# Review of the the Imperial War Museums' report to Cambridgeshire County Council

Produced by:  
Biomass Power Projects Ltd.

10<sup>th</sup> July 2016

Figure showing relationship between various climb rates and clearance over existing trees.

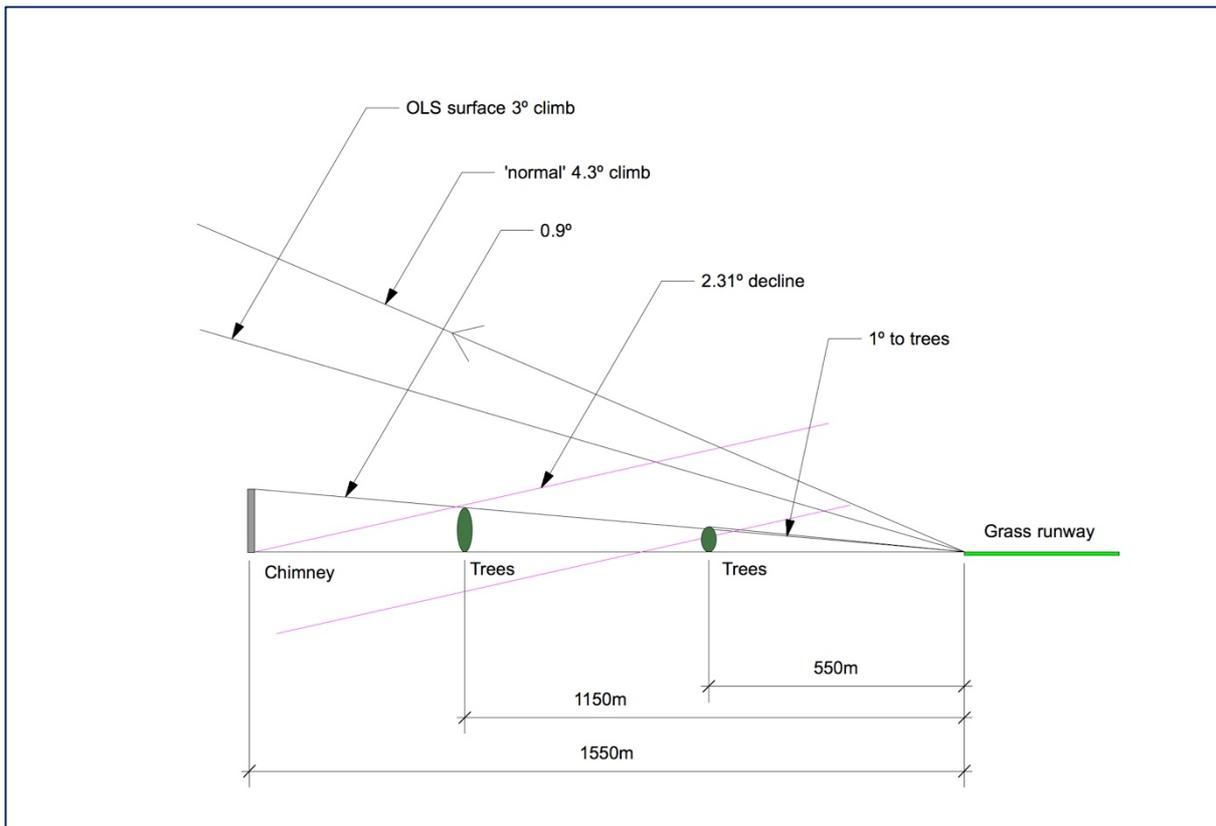
In case B of engine failure it is unclear when this would happen, if it was immediately after take-off, within say 250m then the aircraft would either land or hit the trees on the IWM site. If the engines fail after having cleared the trees at 550m from the end of the runway then it would make a slow descent, (with clear view of what is ahead), it may just clear the second line of trees before coming down at approximately 1500m away at the Vetspeed site or if it had drifted north on A505 or drifted south onto the memorial garden or neighbouring field.

This scenario makes two things very clear, if this plane or any other that cannot maintain an increase in its climb rate will come down at some point resulting in a forced landing and result in a major incident. If engine failure happens at a distance of 550m then the plane will crash land at the Vetspeed site, it will have hit the ground and not the chimney. So this statement and calculation by the IWM confirm that the proposed chimney is not the hazard as it will hit the ground. *The hazard seems to be flying planes that cannot maintain an increase in climb rate and the risk is not just to Vetspeed but the drivers on A505 which are also potentially on the crash line of the plane.*

We conclude that the IWM's scenarios do not conclusively confirm that the chimney is a 'significant hazard'.
